SIENNA PLANTATION EDC
APPROVED DENIED

PLOT PLAN

ADDRESS: 5715 BUFFALO GAP

SUBDIVISION: SIENNA VILLAGE OF ANDERSON SPRINGS

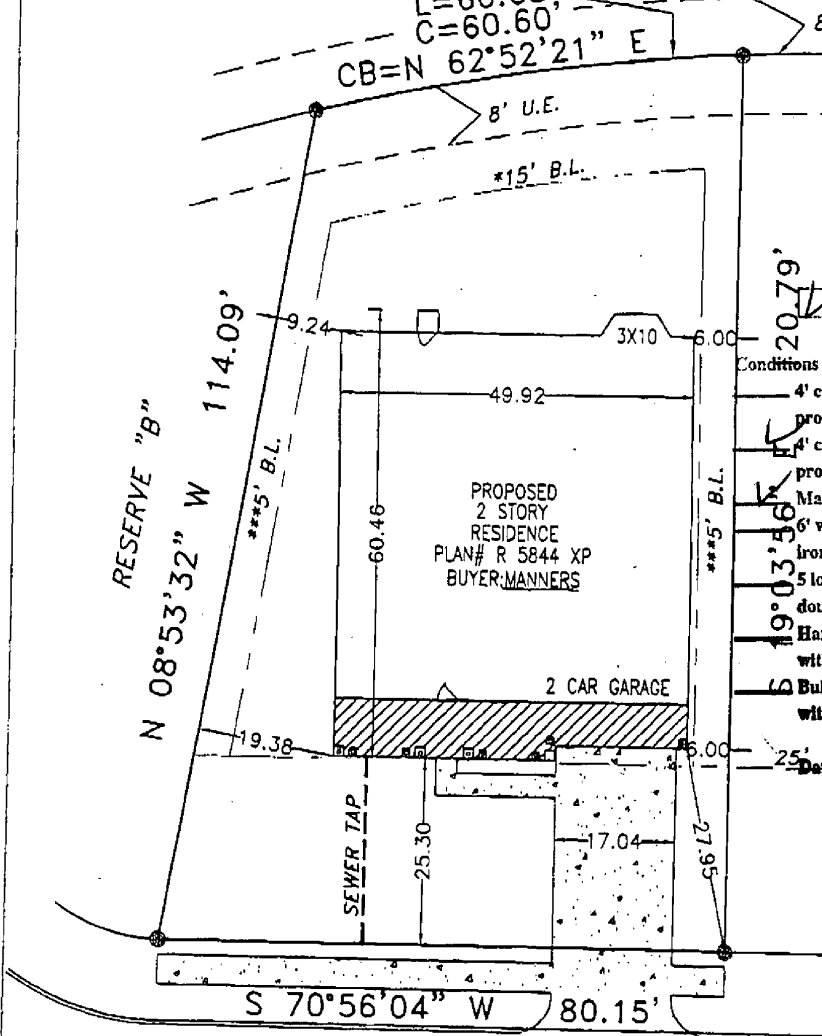
- Conditions for Approval:
- 4' concrete sidewalk to be located 2' inside front property line
 - 4' concrete sidewalk to be located 6" outside front property line
 - Maximum width of driveway at curb is 16'
 - 6' wood fence on sides transitioning to 4' wood post and rail in the rear of the lot is required
 - 5' lot separation required between elevations with double-width garage doors
 - Handicap ramp must be installed in accordance with the City of Missouri City Ordinance
 - Builder is responsible for ensuring compliance with guidelines regarding amenity or view lines
